B737 Flight Control System
Critical Design Review Report
May 3, 1995

**B737 FLIGHT CONTROL
SYSTEM
CRITICAL DESIGN REVIEW
-REPORT-**

B737 FLIGHT CONTROL SYSTEM CRITICAL DESIGN REVIEW TEAM -

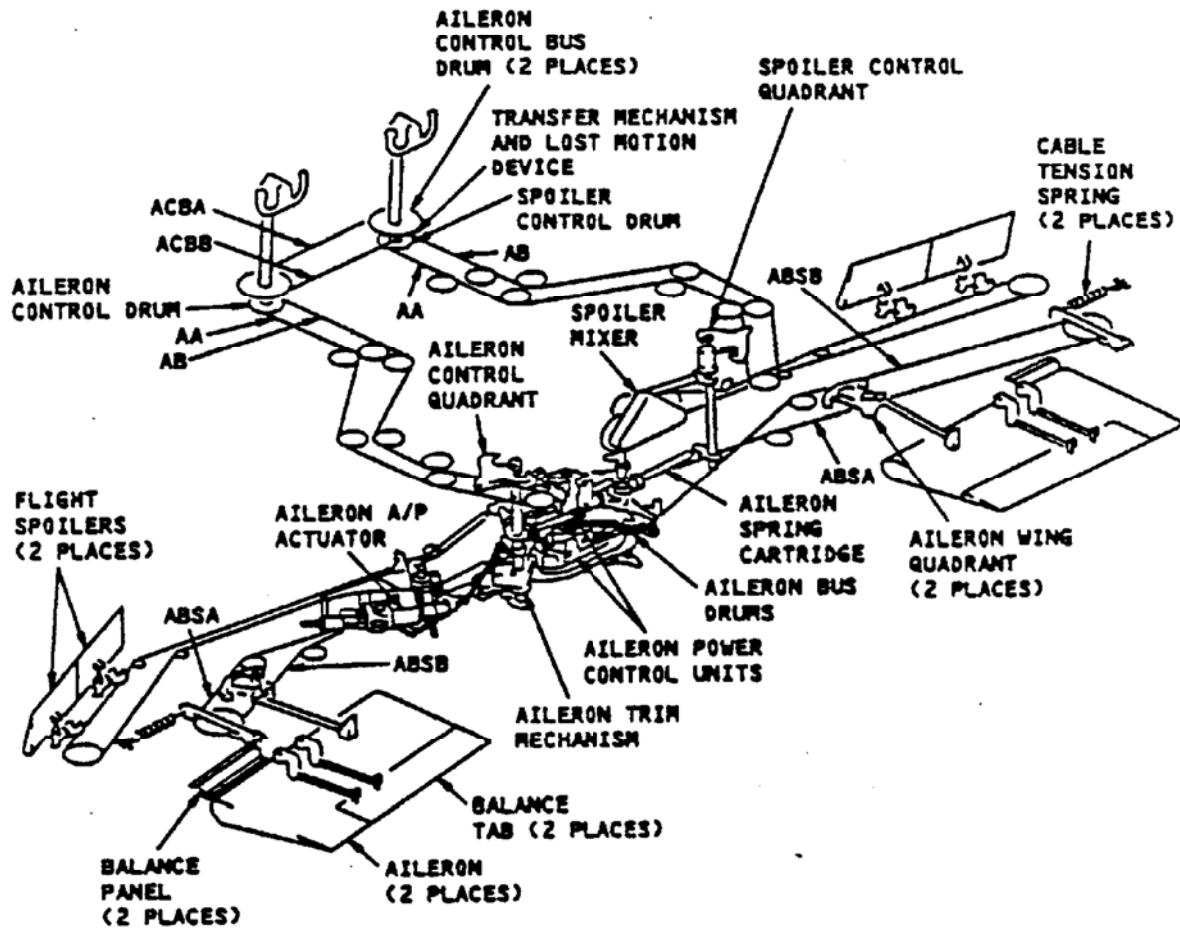
a. Single Failures, Aileron - The failure mechanisms identified in Table 1 suggest there are a number of ways for a failure to result in a sustained aileron hardover. The significance of the aileron failure conditions resulting in a jam of the aileron is the importance of the alternate means for controlling the airplane. The designed alternative means is the aileron transfer mechanism.

As was experienced in the "M" Cab exercise, flight path control through the aileron transfer mechanism may be very difficult due to the high wheel forces. It is believed that if a full aileron hardover was to be countered for any reasonable length of time, continued safe flight and landing in a B737 would be very difficult. (See "Recommendations For FAA Action," Section 15. Recommendation -8).
